# Early Design Guidance - 1402 Aurora Ave. N Project

Project #3025059

First Early Design Guidance Of  
The West Design Review Board

June 7th Design Review Responces:

Roof Plan

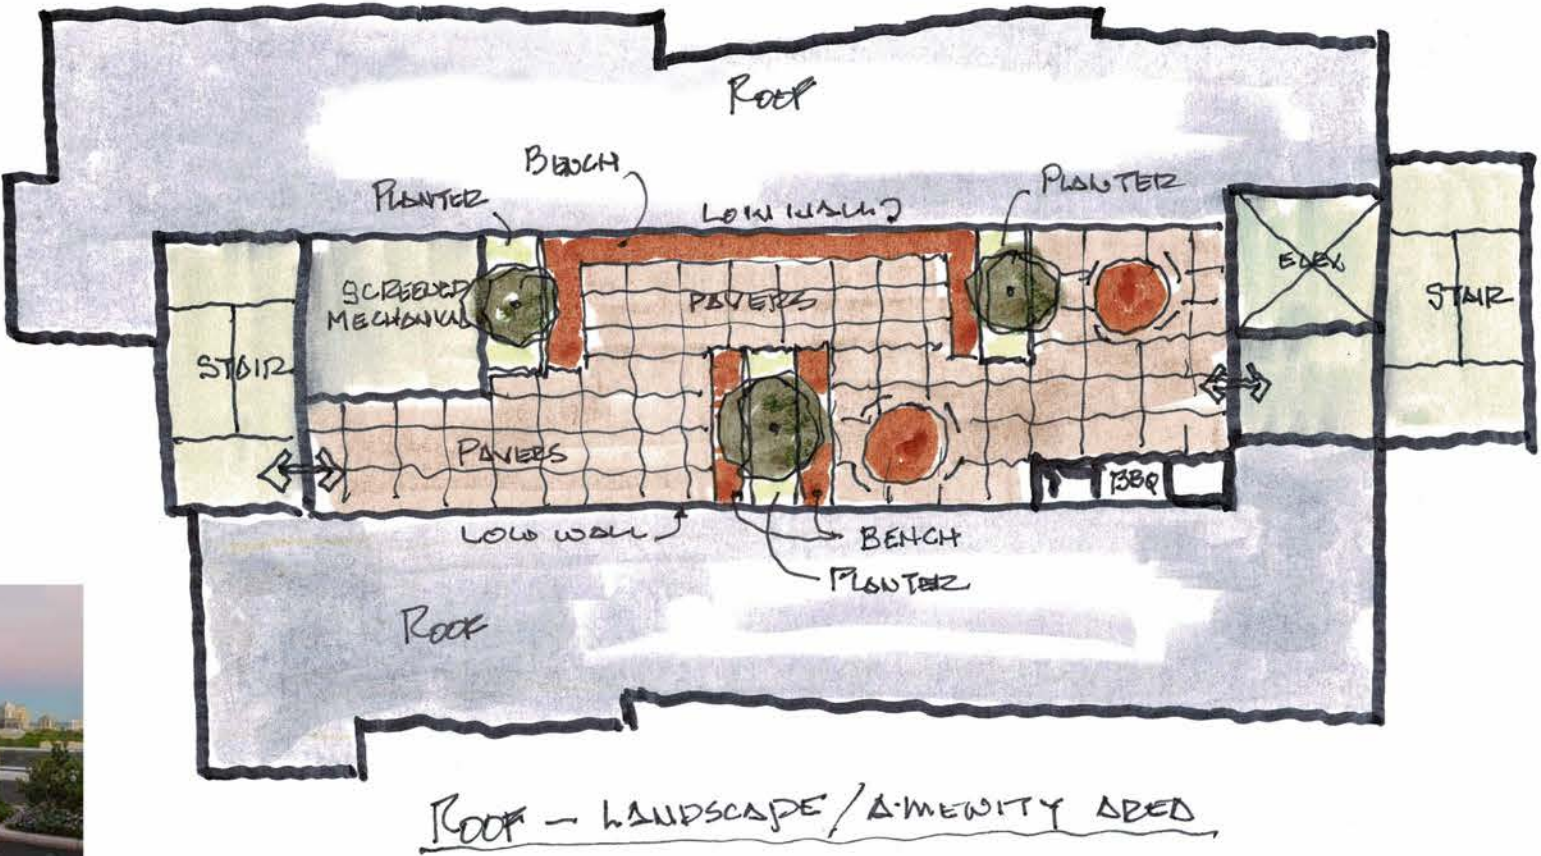
f. The Board heard public comment, and requested additional information on the design of the rooftop, including where active areas are located and how mechanical systems are screened. Due to topography and the high visibility of the rooftop from uphill, the rooftop should be designed as a fifth facade. (DC2-I-i)

*Please see revised Roof Plan & Landscape Plan Pg., 24*

Pedestrian Access Study at Lee Street

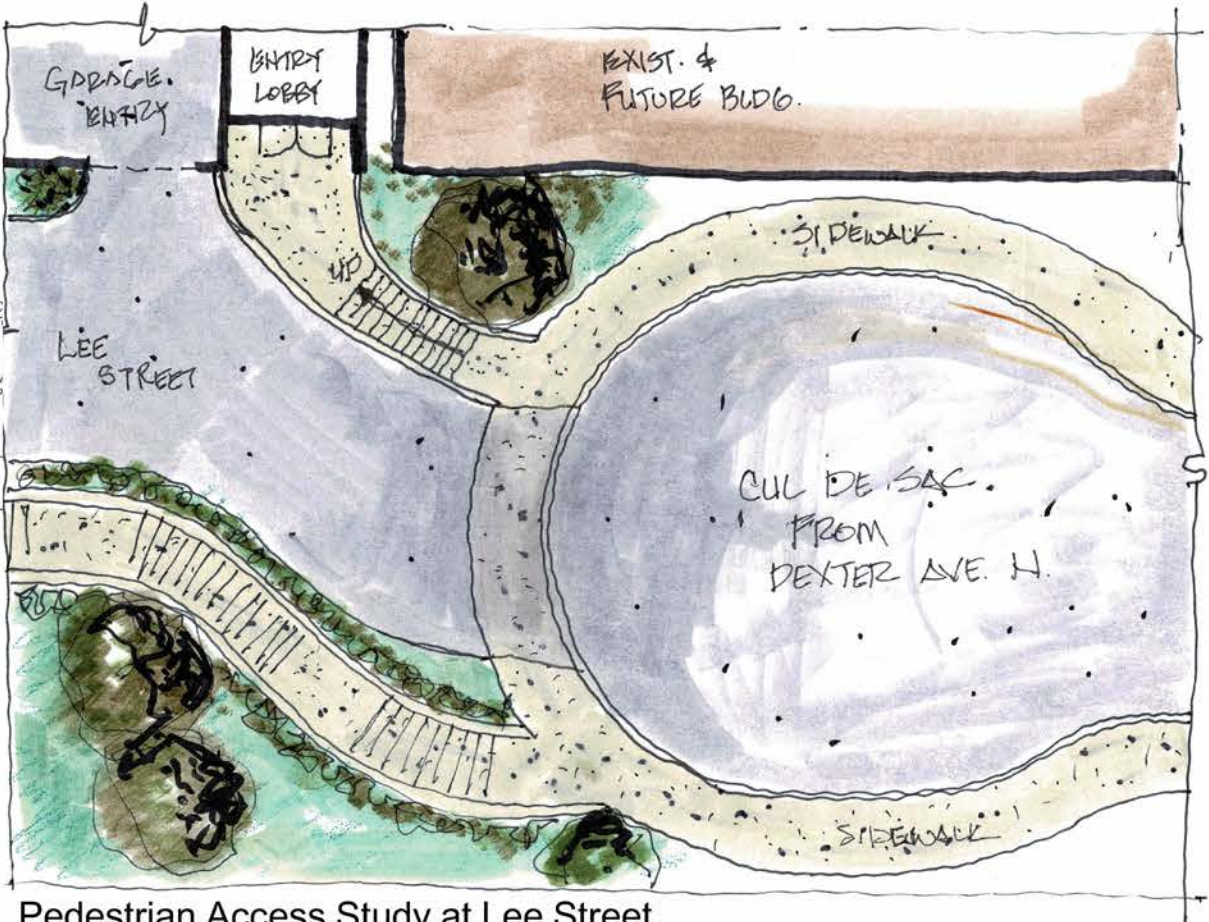
a. The Board discussed the importance of place-making along Lee St. Since the Lee St façade is likely be perceived as the "front" of the building, it is important that the proposed development makes a strong connection to the street. The Board was concerned with the pedestrian experience along Lee St, particularly the canyon-like right-of-way improvements, the pedestrian entry, and conflicts with vehicular access. (CS2-B-2, PL1-B, PL2-A-1, PL4-B-2, DC1-B-1)

*Please see studies Pg., 25*

Green Wall Systems

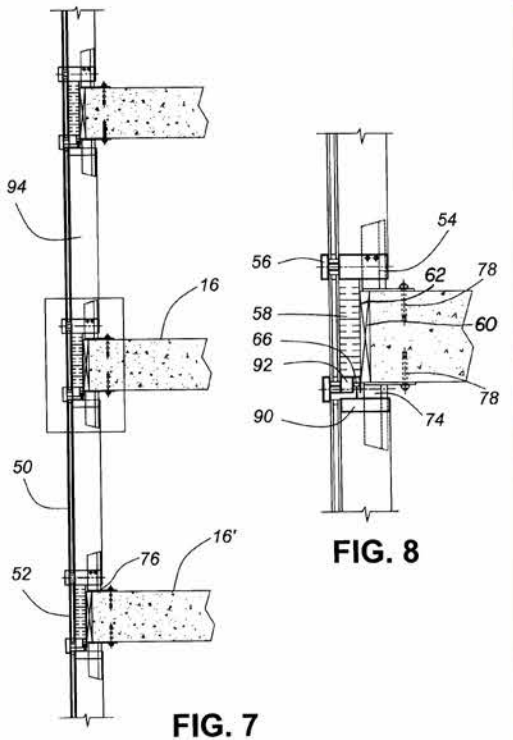
a. In agreement with public comment, the Board supported the proposed green wall provided that the concrete wall behind the green wall is highly textured to provide visual interest in the interim. The design of the concrete wall and green wall should be a multi-layered approach. (DC2-D-2)

*Please see Pg., 27, 28 & 29*

Curtain Wall Details

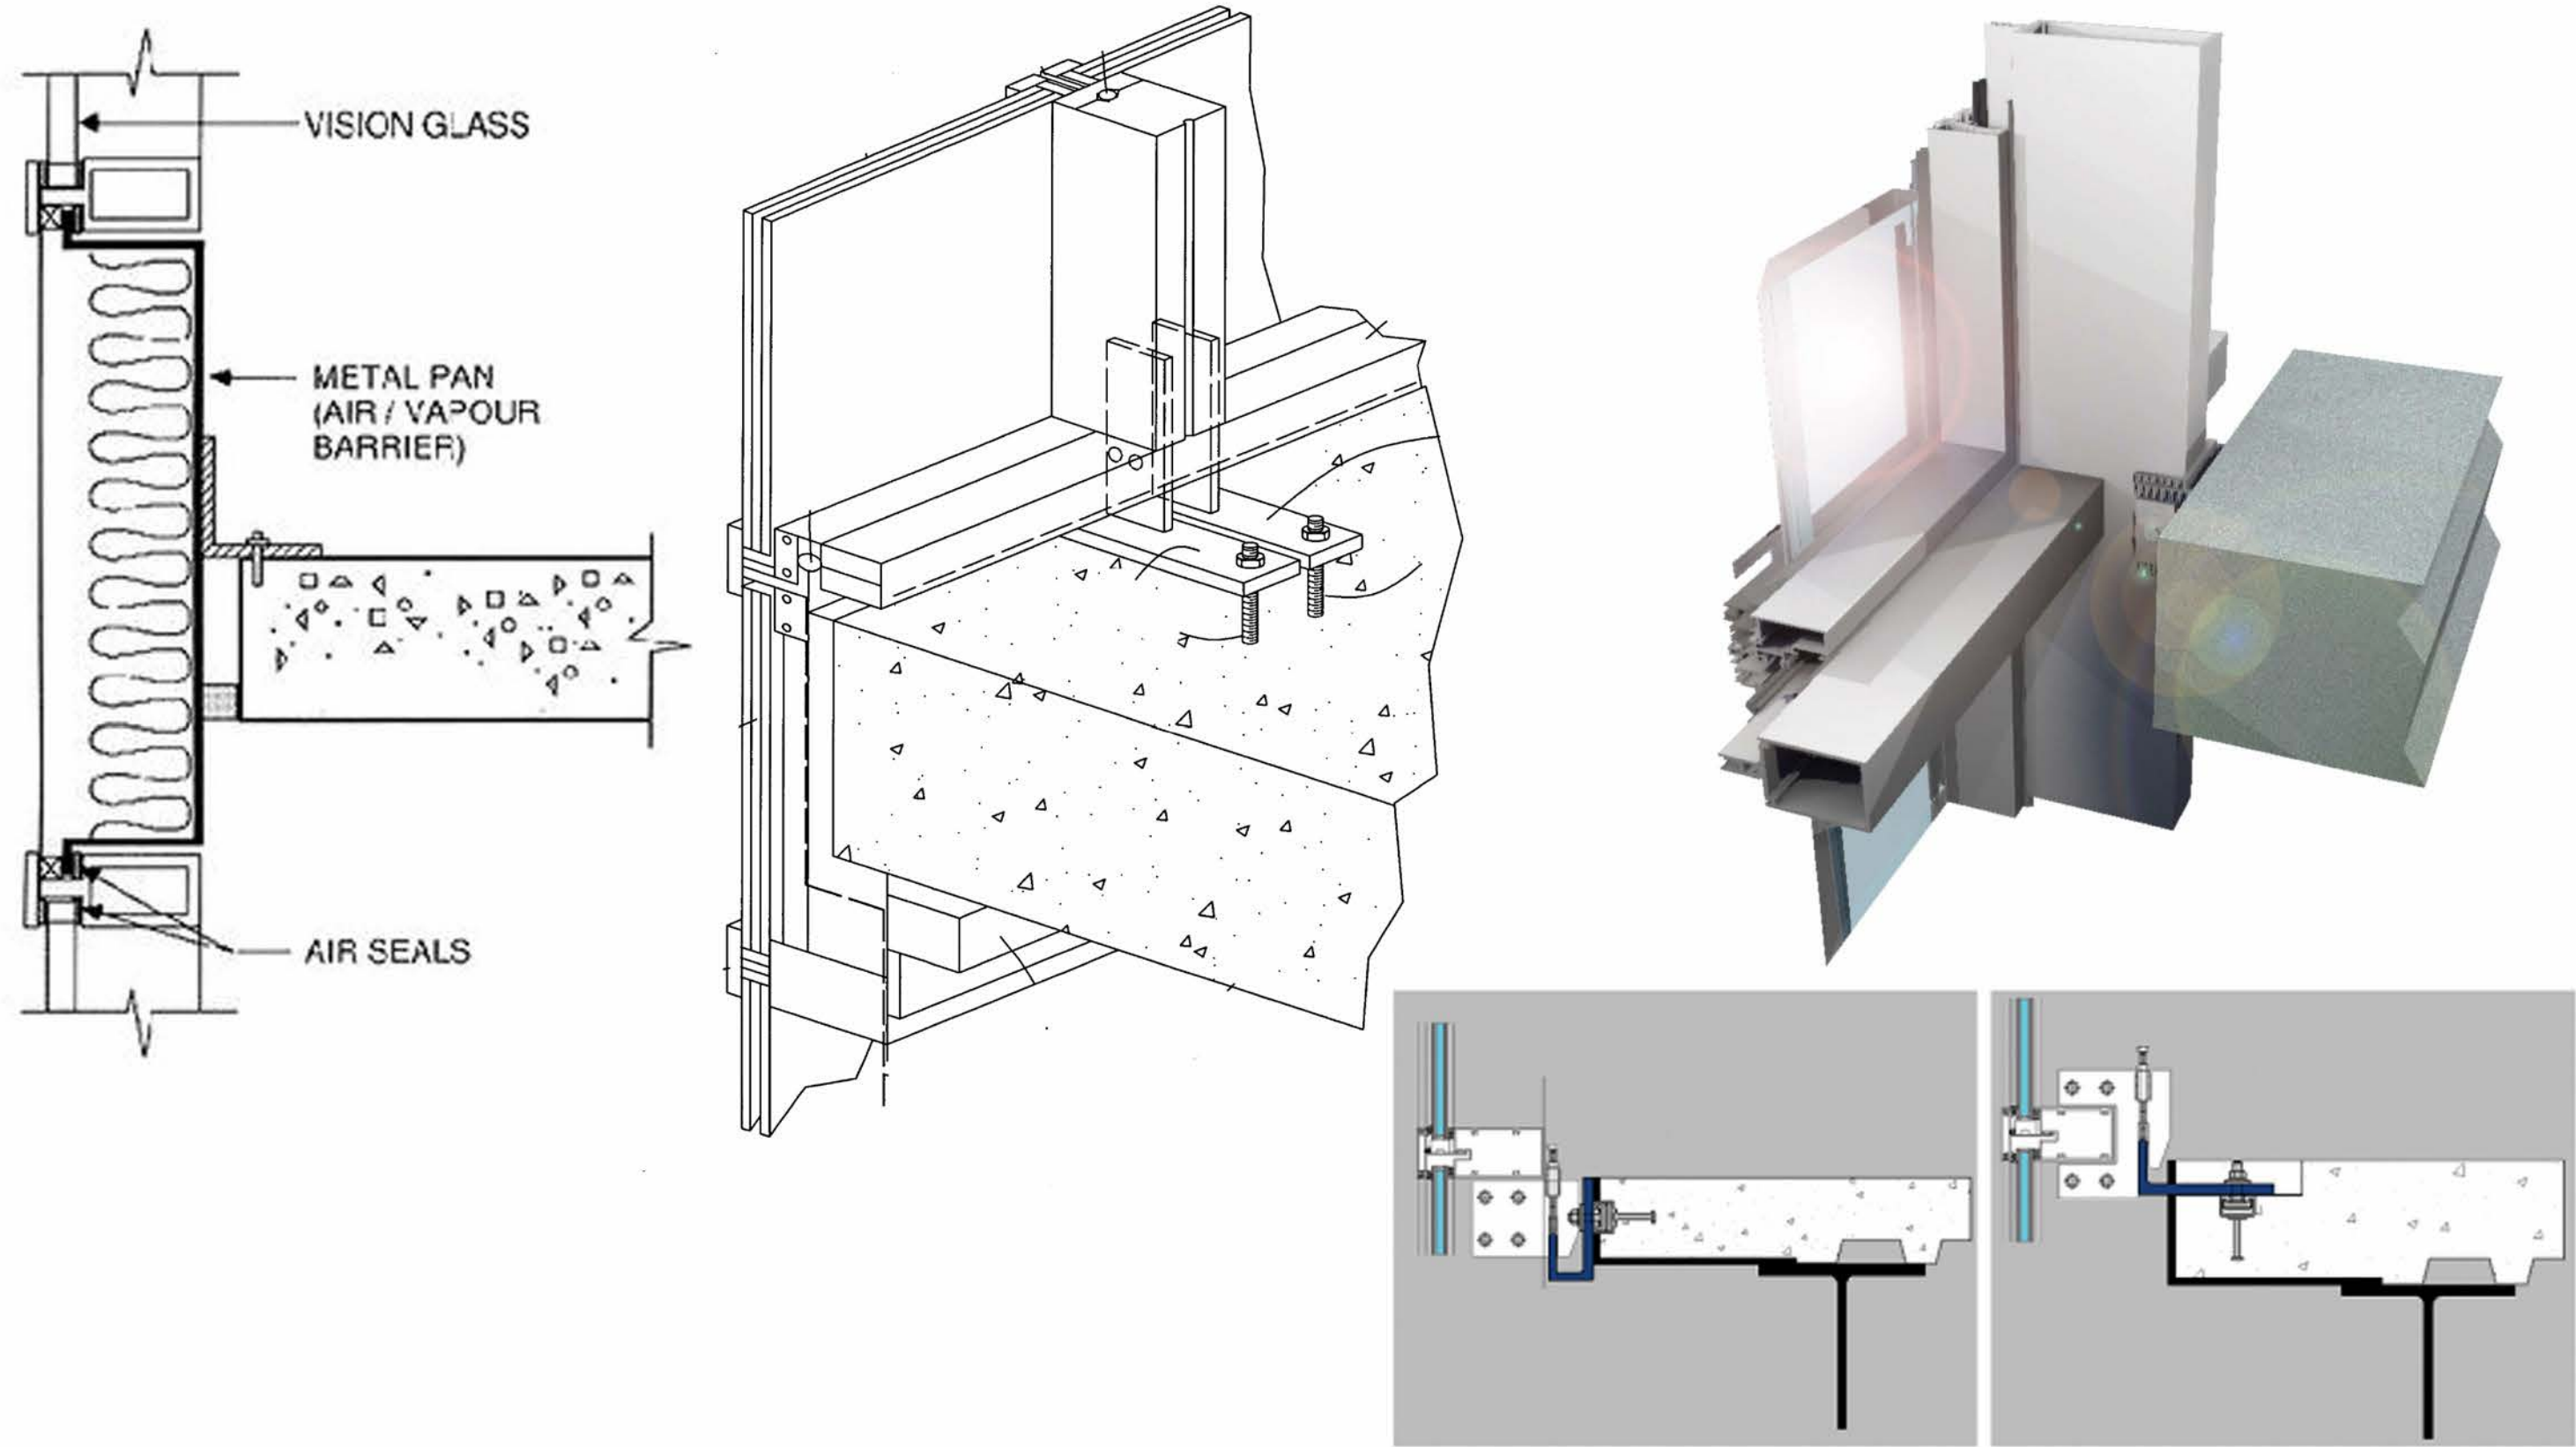
a. The Board supported the "glassy cube" architectural concept, however, they noted that the success of the concept would be dependent on the type of curtain wall system selected, and requested additional materials research in order to better inform their guidance on the proposed mass. (CS3-A-2, DC4-A)

*Please see Pg. 30*
